PROPOSED CHANGE NO. SC-01-002R1

Date: July 24, 2025
File: 9.1.7.4.2_SC-01_PC
Project No.: 2215C
Project: TA Blakelock HS Reno - Phase 3
Subcontract: SC-01 General

Description: Elevator 2 (drama area)

CONTEMPLATED CHANGE NOTICE No. S1

2 PARTIAL FLOOR PLAN - LEVEL 0
A100 1:50

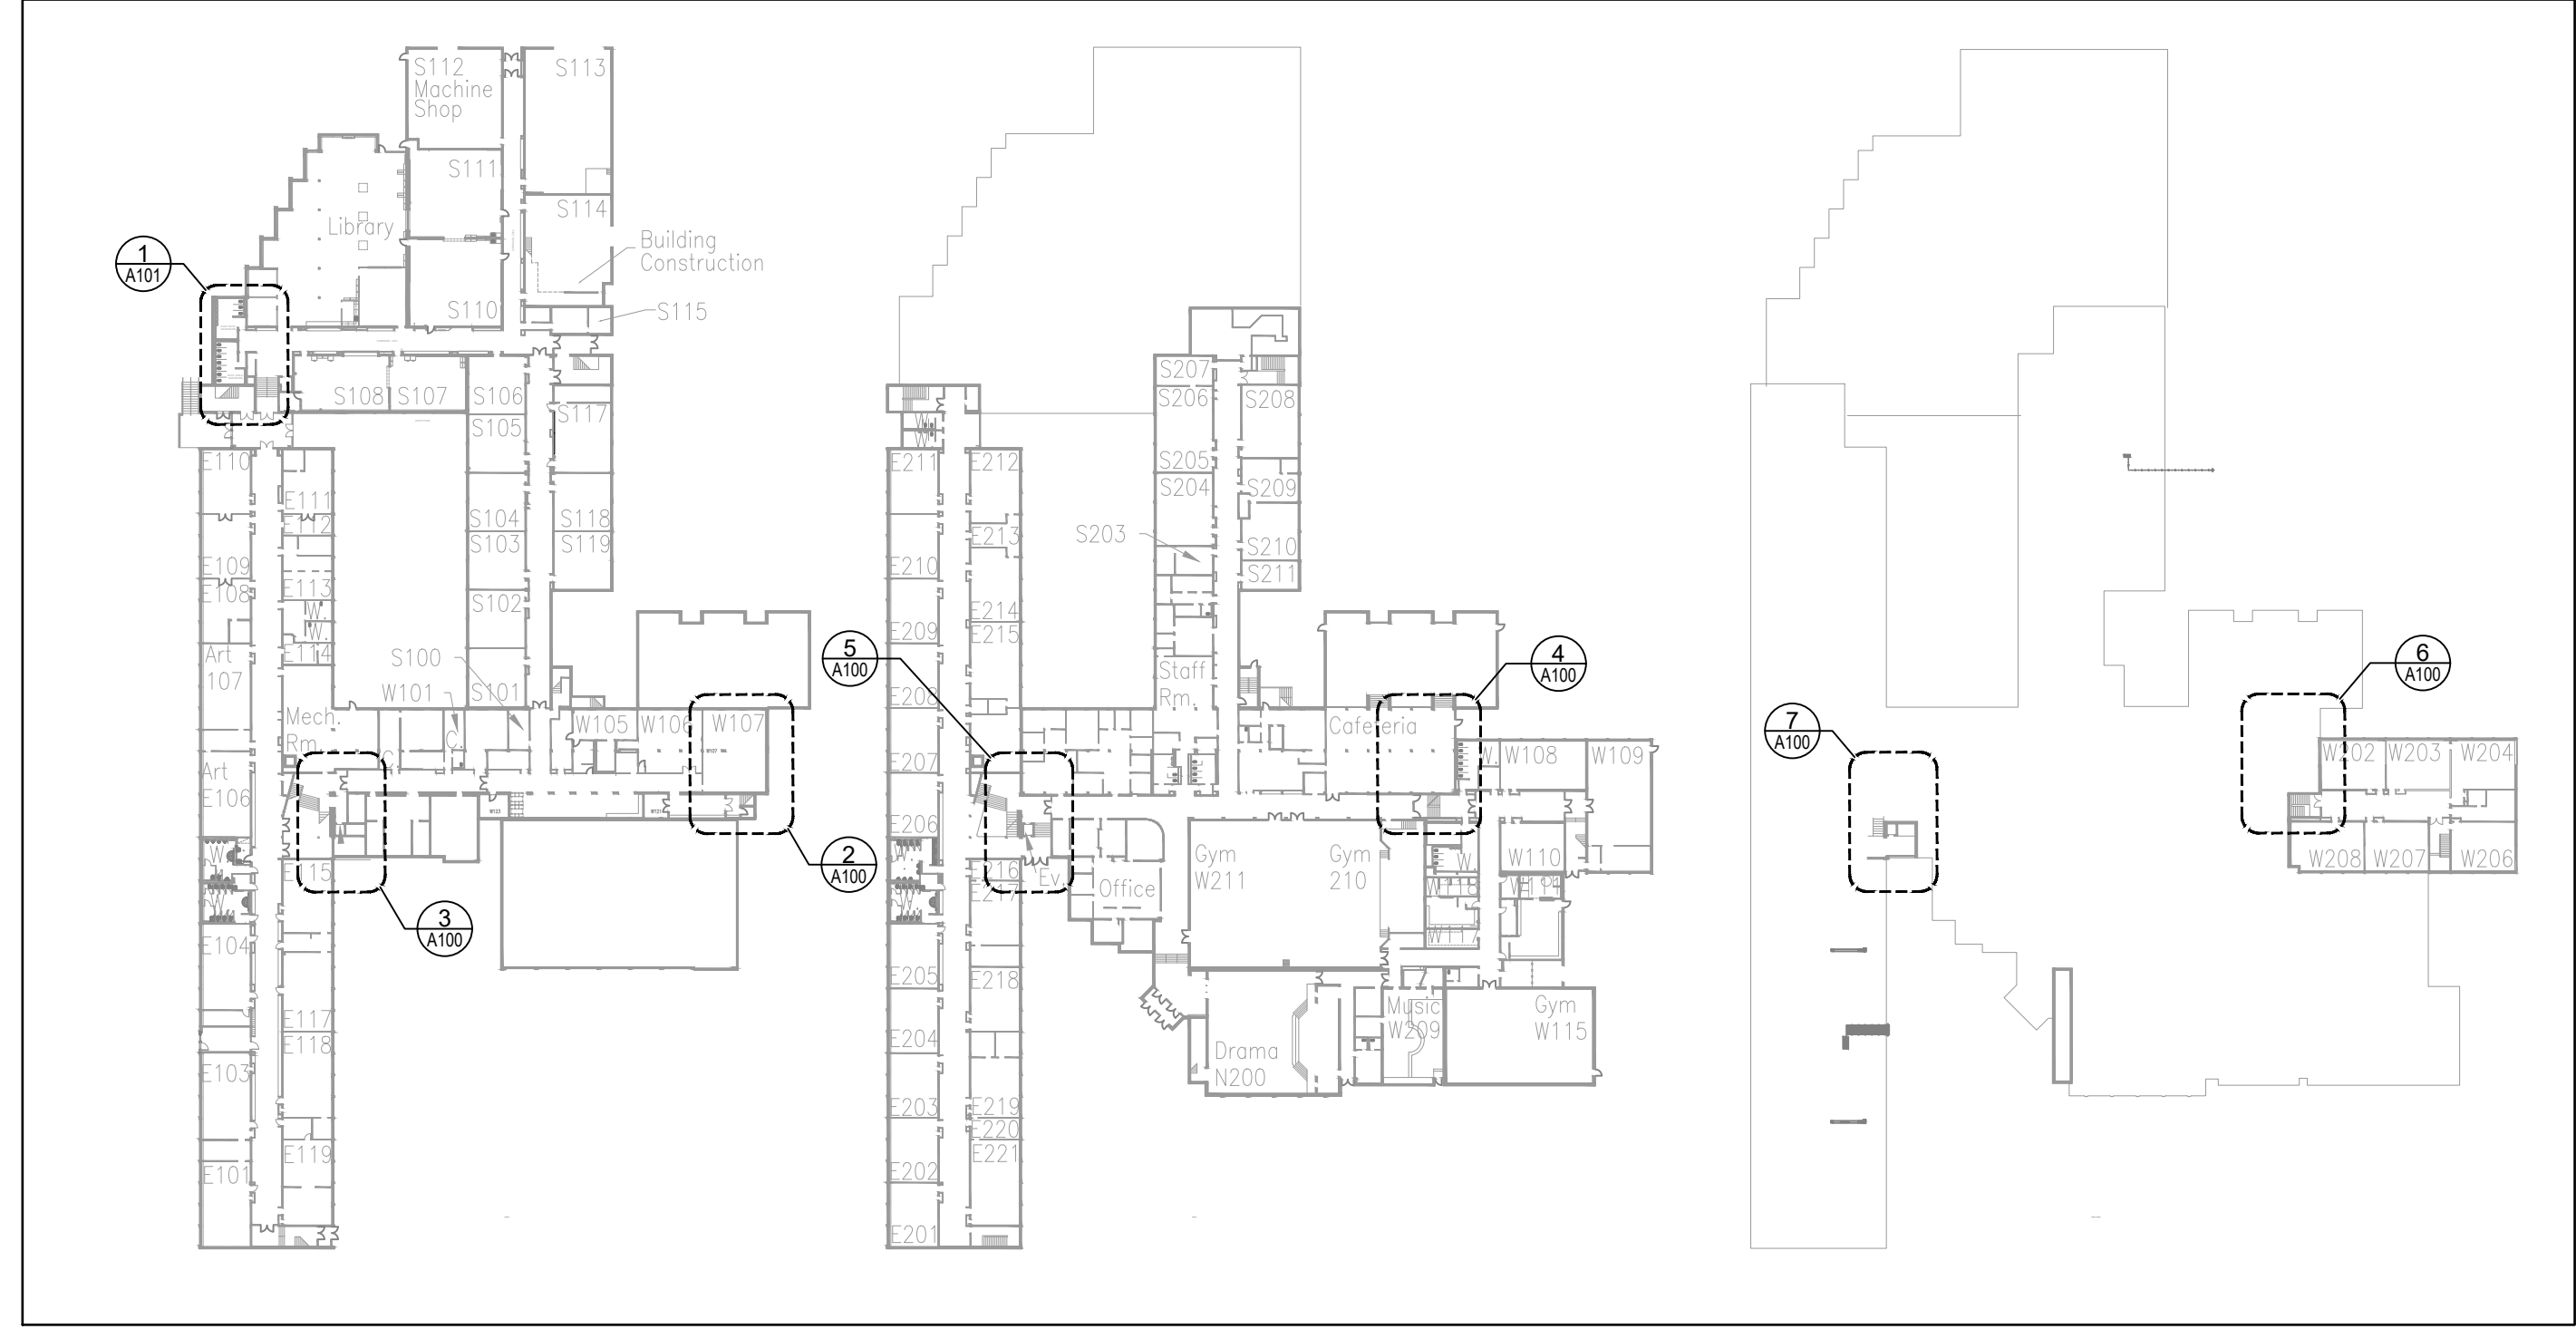
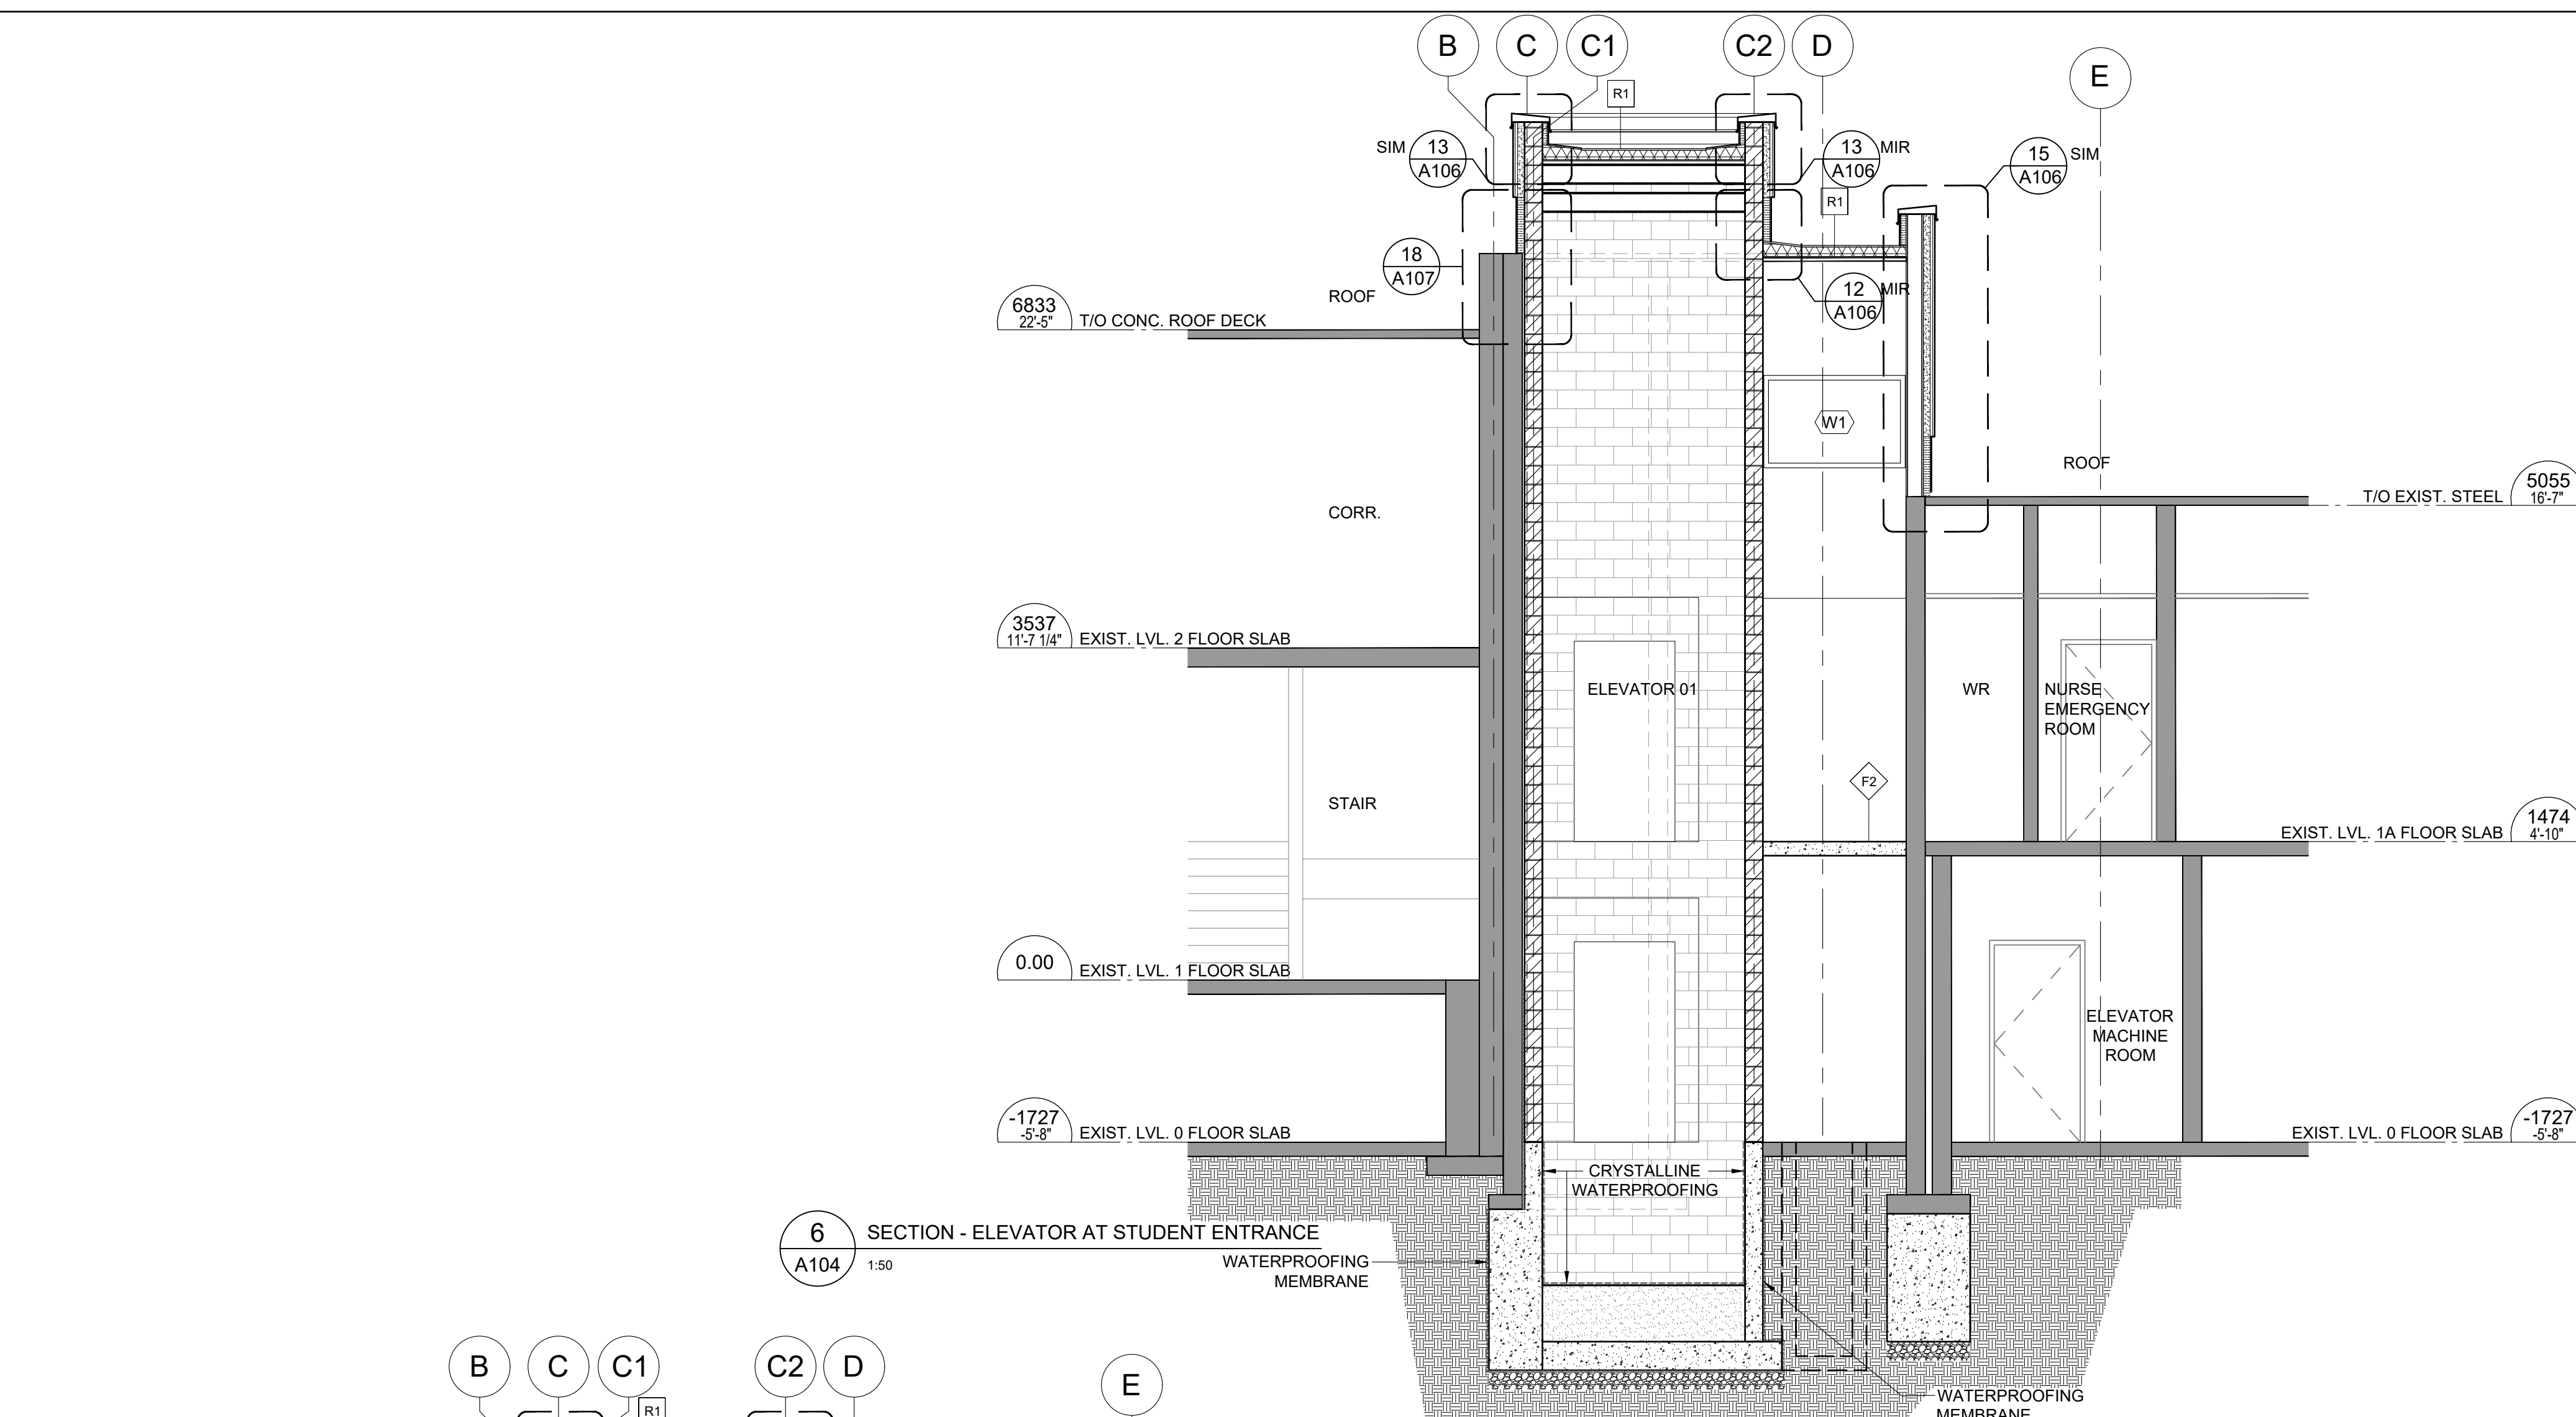
1. Refer to attached updated A100 floor plans and A104 updated sections.
2. Refer to Structural CONTEMPLATED CHANGE NOTICE No. S1 item 1 for requirements.
3. Mechanical CCN to follow adjusting sump pit location and corresponding drainage and piping to it. Electrical CCN to follow confirm power and control until location for sump pit.
4. Refer namely to sump pit relocation, deletion of underpinning along West side of Drama Room (Refer to Structural CCN for scope).
5. Provide 36x 36 ACUDOR FT-8050 concrete floor door, single leaf, 1" recessed to receive flooring. Provide cut sheet. Note this ACUDOR is intended to clear the 24" dia sump pit including sump pit flange. Confirm with vendor. Set sump pit lid just at u/s of lid opening. Provide cut sheet of ACUDOR. Run sump pit venting and discharge line within adjacent 190mm CMU wall.
